UNITED STATES PATENT AND TRADEMARK OFFICE

APPLICATION NO.	FILING DATE	FIRST NAMED INVENTOR	ATTORNEY DOCKET NO.	CONFIRMATION NO.
10/694,816	10/29/2003	Karl-Heinz Maus	024943-056	6775
21839	7590	09/19/2006	EXAMINER	
BUCHANAN, INGERSOLL & ROONEY PC POST OFFICE BOX 1404 ALEXANDRIA, VA 22313-1404			ALEJANDRO, RAYMOND	
			ART UNIT	PAPER NUMBER
			1745

Office Action Summary

DETAILED ACTION

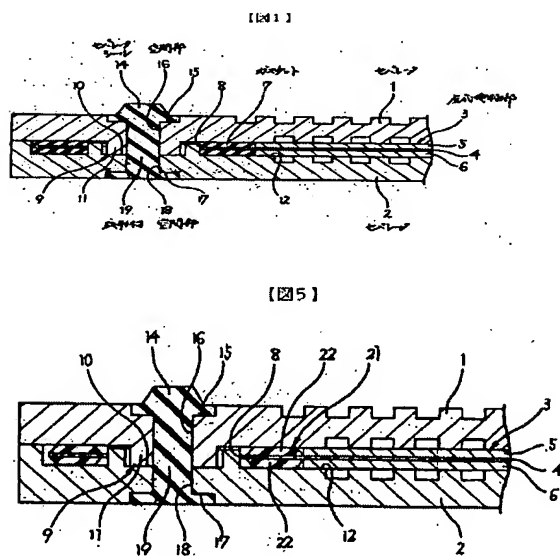
The JP'673 discloses two or more separators 1, 2 being unified in a stack fashion by injection molding of a molding material 19 which consists of a rubber, a liquid rubber, or a thermoplastic elastomer (*all of the are polymeric materials*) (ABSTRACT). **Figure 7** illustrates the final fuel cell arrangement composed of multiple individual components being stacked together.

Figures 1 and 5 below illustrate the specific fuel cell arrangement or configuration including plates 1 and 2 and a molding material 19 injected onto the plates to seal them so as to form a joined structure.

As illustrated in **Figures 1 and 5** above, each plate 1, 2 has an opening or aperture and the seal element (reference numeral 19) extend therethrough (See also **enlarged portion of Figure 1** below). *In this instant, the cavity having the seal may be either the upper portion of plate 1, or the lower portion of plate 2, or the interface portion between plates 1 and 2.*

Molding material 19 (the seal element) is disposed on the main surfaces of the stack and the seal element encompasses end faces of the plates (See **Figures 1 and 5**). Plates 1 and 2 are placed immediately adjacent one another and there is an empty space therebetween (See **enlarged portion of Figure 1** below).

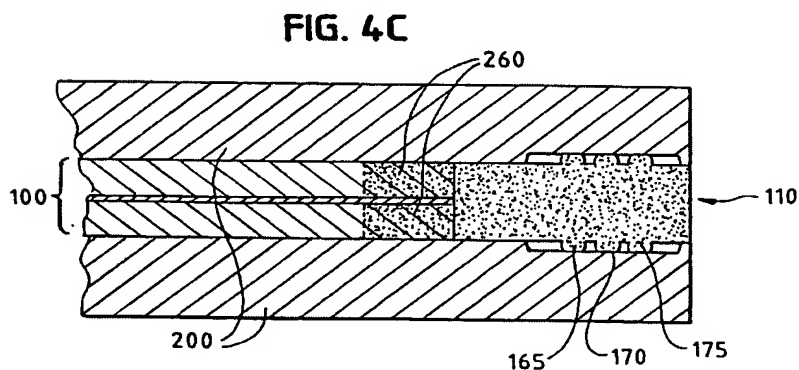
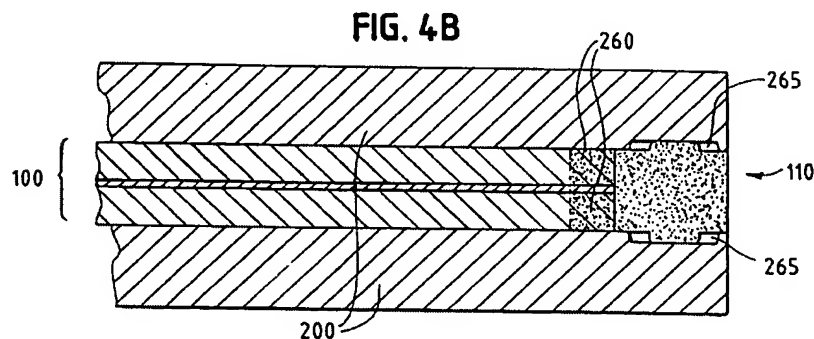
Figures 4B-C of the WO'446 depict a seal for membrane electrode assembly 100 in an electrochemical fuel cell and method of making same (TITLE) including separator plates 200 (Page 13, lines 7-20) including openings (recessed groove 265) and having injected therein an integral seal 110 to join the plates together at a lateral side thereof (Page 13, lines 7-20 & See Figures 4B-C). The integral seal for a plurality of sealing regions of the porous electrode layers 140 could be injection molded (Page 11, lines 5-10). The sealant material is a polymeric material (Page 10, lines 19-23).

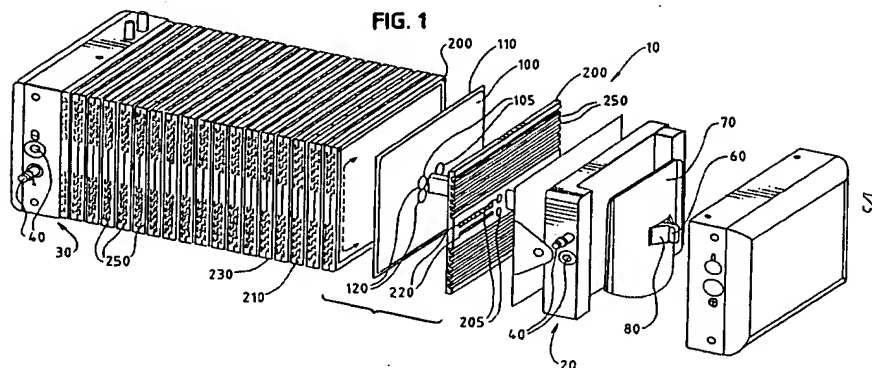
Figure 1 illustrates multiple individual components stacked together to form a fuel cell module or arrangement.

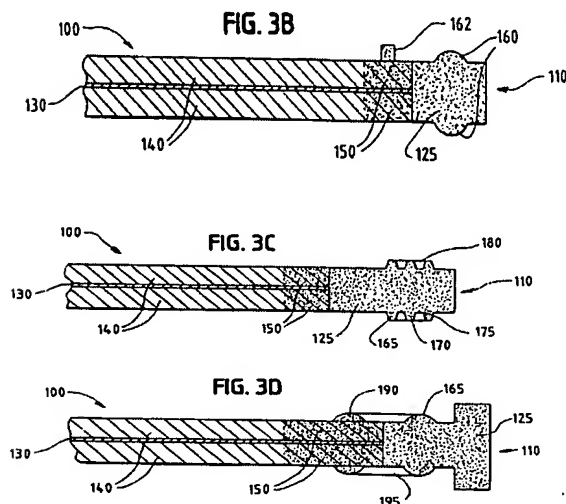
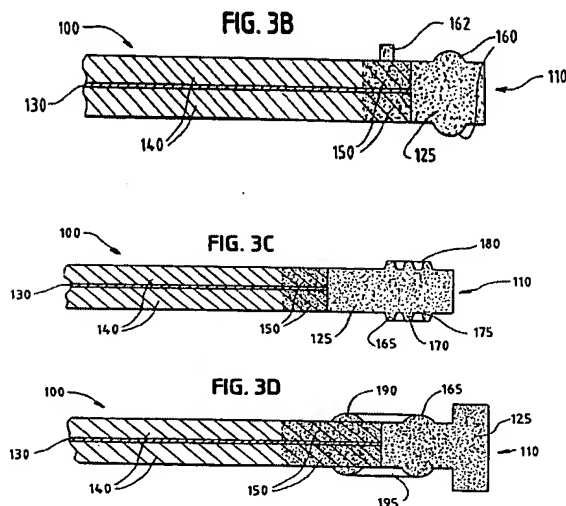
The WO'446 shows in **Figures 3B-D** below seal elements comprising tapered structures and flat surfaces. Specifically, **Figure 3C** does show the flat surface being separated from the tapering surface by a recess.

The WO'446 shows in **Figures 3B-D** below seal elements comprising tapered structures and flat surfaces. Specifically, **Figure 3C** does show the flat surface being separated from the tapering surface by a recess.
